City of Denton

Meeting Agenda Planning and Zoning Commission

Wednesday, May 13, 2026

- A. [FP26-0012b](#) Consider a request by Mack Mattke of Kimley Horn & Associates on behalf of CATDENTON 35 for a Final Plat of Summit 35 Addition. The approximately 68.175-acre property is generally located east of North Interstate 35, north of Loop 288, and southwest of Highway 77 (North Elm Street) in the City of Denton, Denton County, Texas. (FP26-0012b, Summit 35, Julie Wyatt)

APPLICANT:
Kimley-Horn and Associates, Inc.
100 W. Oak St., Suite 203
Denton, TX 76201
Ph: 940-287-3620
Contact: Mack Mattke, P.E.

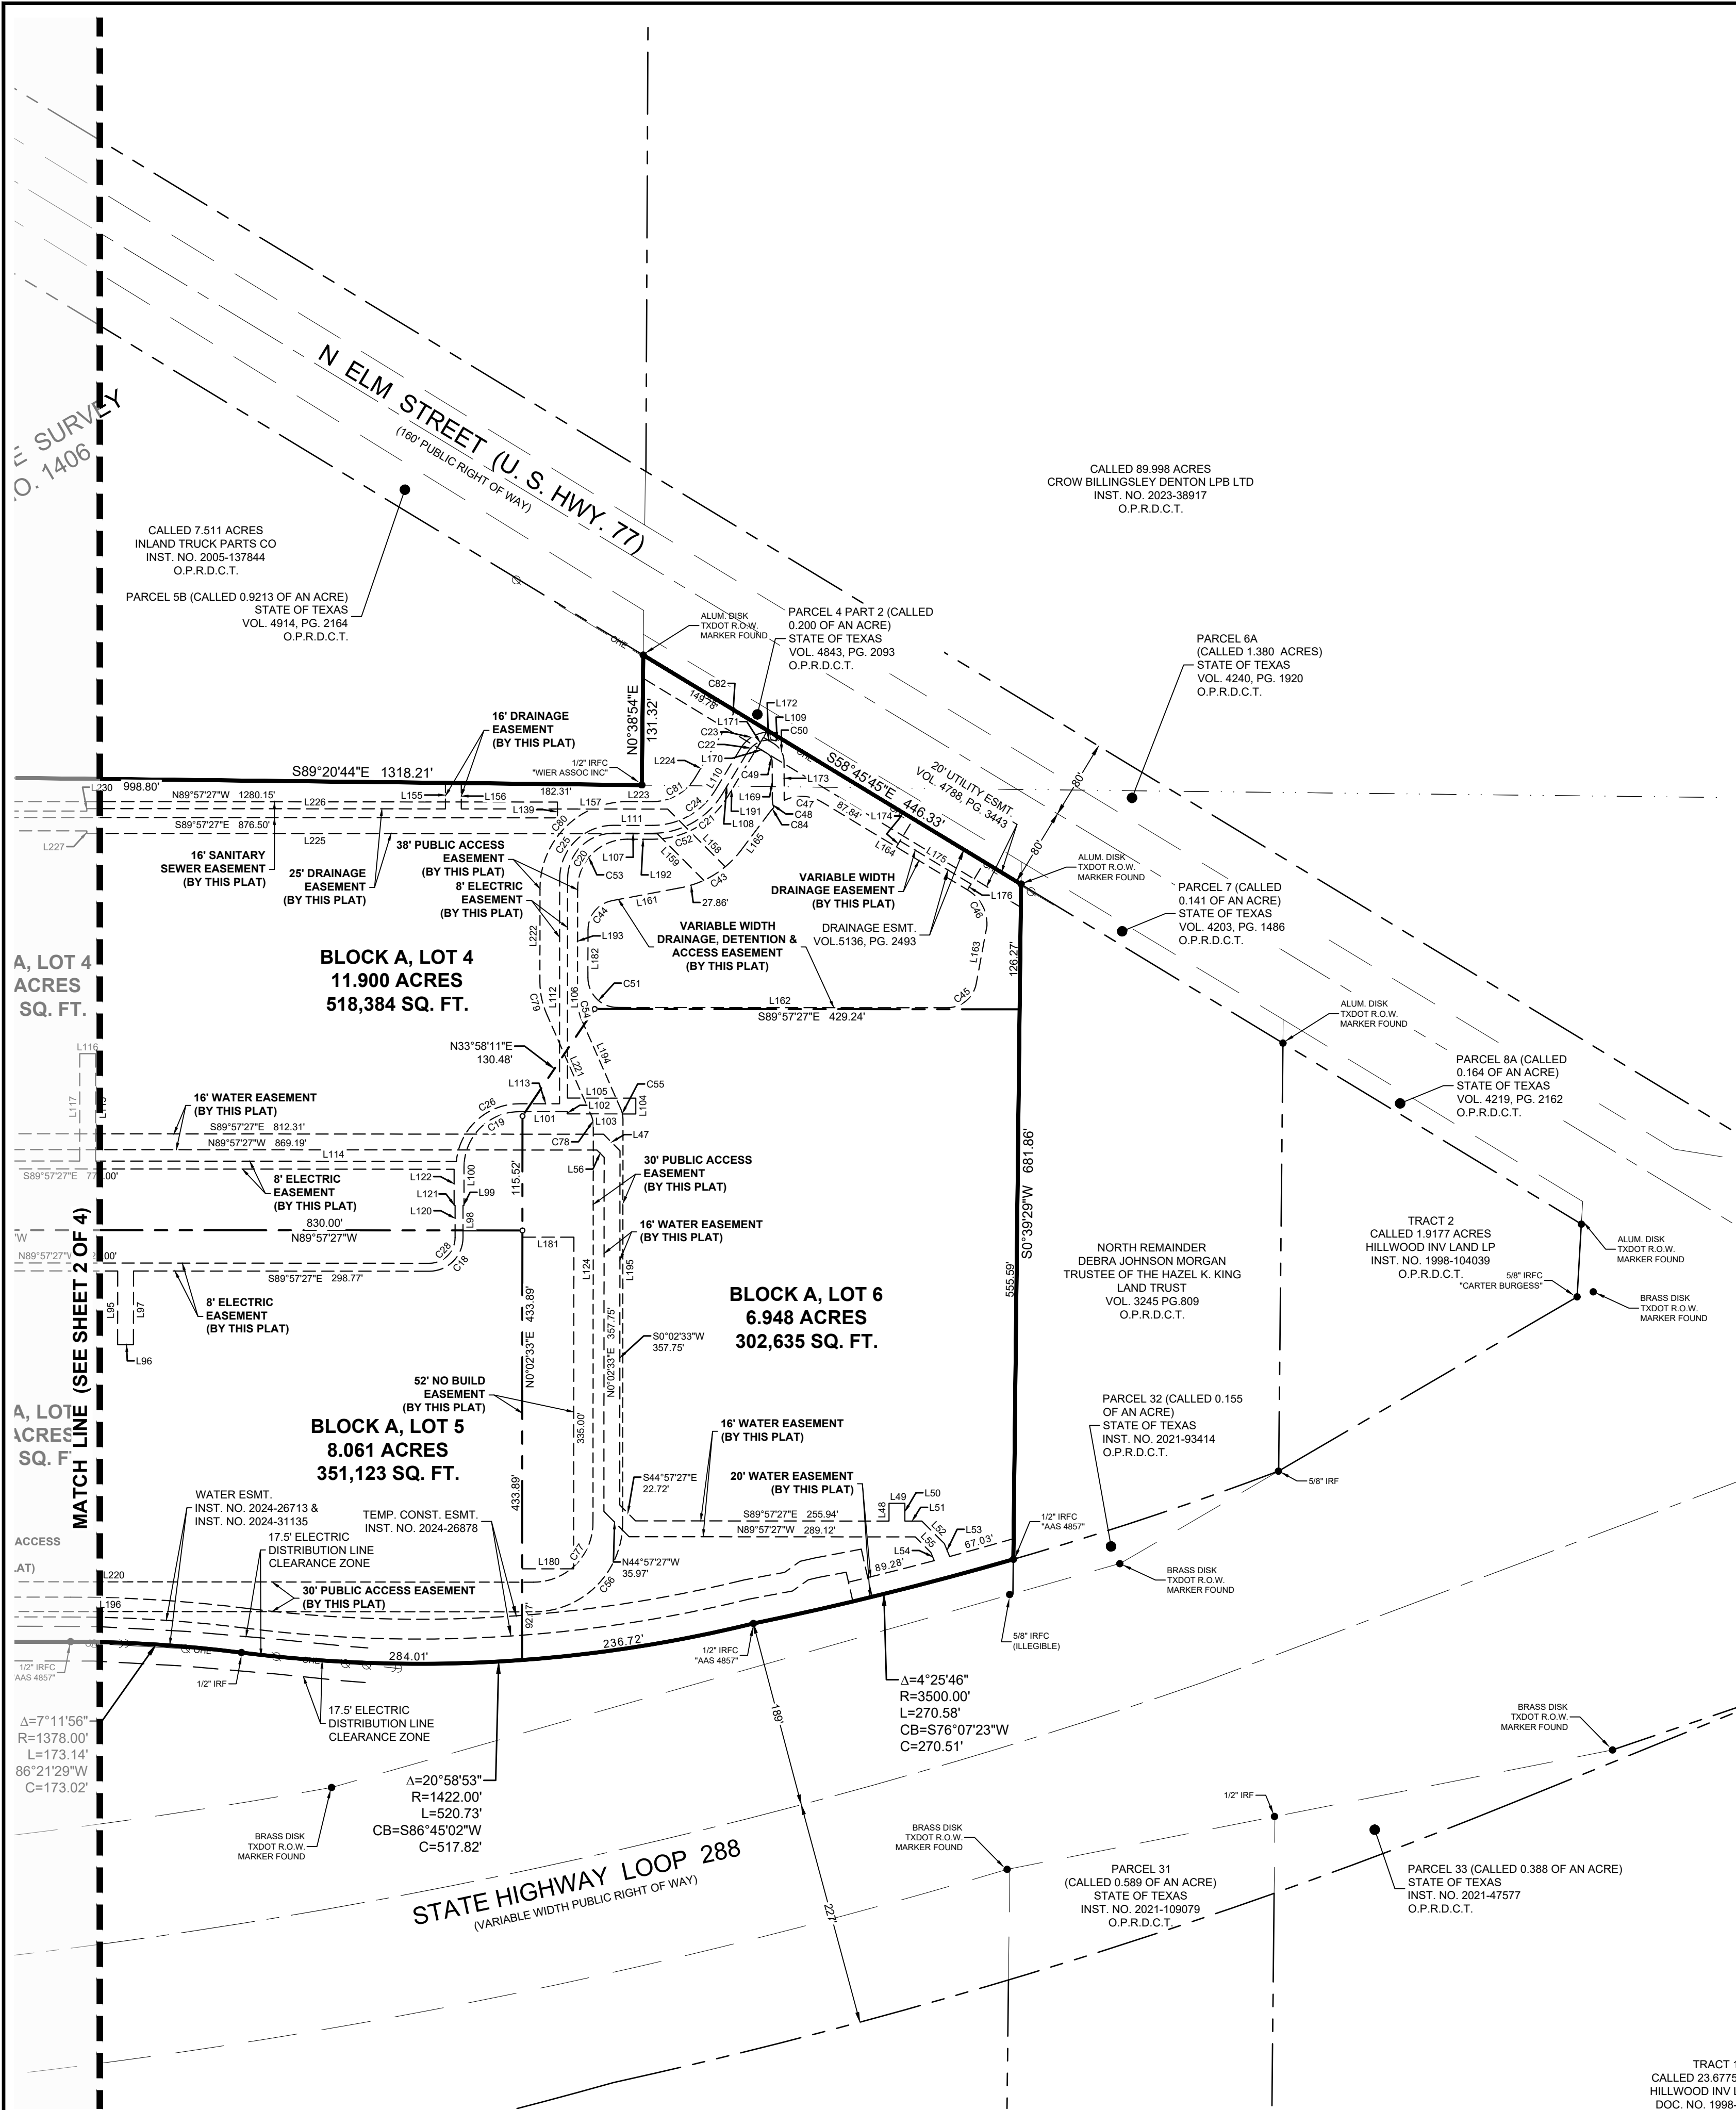
Approval Criteria Applicable to all Applications (DDC Section 2.4.5.E)		Compliance		
		Met	Not Met	N/A
2. Prior Approvals				
a. The proposed development shall be consistent with the terms and conditions of any prior land use approval, plan, development agreement, or plat approval that is in effect and not proposed to be changed. This includes an approved phasing plan for development and installation of public improvements and amenities. Findings: The proposed Final Plat is consistent with the zoning requirements. In order to comply with the criterion, the following must be addressed: Pending CEP25-0080 approval (DDC 2.6.4C.2.d)		☐	☒	☐

4. Compliance with this DDC				
a. The proposed development shall comply with all applicable standards in this DDC, unless the standard is to be lawfully modified. Findings: The Final Plat does not comply with the applicable DDC requirements as described herein. See Criteria #2 and 15 for details.		☐	☒	☐

5. Compliance with Other Applicable Regulations				
a. The proposed development shall comply with all other city regulations and with all applicable regulations, standards, requirements, or plans of the federal or state governments and other relevant jurisdictions. This includes, but is not limited to, wetlands, water quality, erosion control, and wastewater regulations. Findings: The proposed Final Plat does not meet all criteria set forth by the Final Plat Checklist, authorized by DDC Subsection 2.6.4D.3. See Criteria # 2 and 15 for details.		☐	☒	☐

15. Whether the development will substantially comply with all requirements of this DDC. Findings: The Final Plat does not comply with the applicable requirements of the Denton Development Code as described herein and as outlined below: 1. Drainage easements are subject to further review based on pending comments from CEP25-0080. Boundaries sha also be dimensioned (DCM 4.12 and FPC 3.7) 2. Proposal shows drainage and detention easement encroaches into No Build Easement. Provide information as to what types of encroachments are permitted (DDC 7.8.10) 3. Confirm allowable improvements in No Build Easement. If none allowed, fire lane access will encroach into this easement and must be relocated. (DDC 7.8.10)		☐	☒	☐

16. Whether the development will comply with the applicable technical standards and specifications adopted by the City. Findings: The Final Plat does not comply with the applicable technical standards and specifications as described herein. See Criteria #2 and #15 for details.		☐	☒	☐

On behalf of the owner and applicant, I request that the final plat associated with FP26-0012 be granted a 30-day extension at the May 13th Planning and Zoning commission meeting in order that staff's comments may be more fully addressed for consideration at the May 27th, Planning and Zoning commission meeting.
